PRODUCT/PROCESS CHANGE NOTICE (PCN)

PCN #: **SR-0505-02** DATE: **8/3/2005**

Product Affected: FPBGA 165 (BQ165) Package

PCN Type: Change in solder pad opening and ball diameter for FPBGA 165 (BQ165) package.

Example of FPBGA 165 Package Top Mark

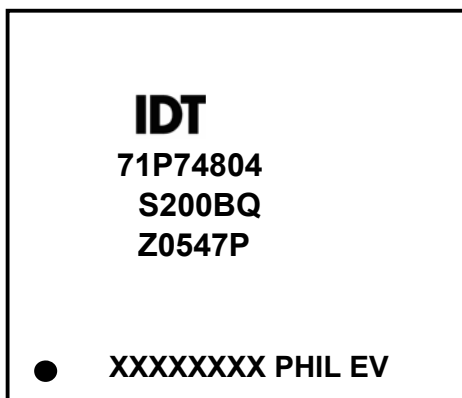
Encrypted assembly date code suffix on the assembly lot number

XXXXXXXX = Assembly Lot Number
PHIL = Country of Origin
EV = Assembly Date Code
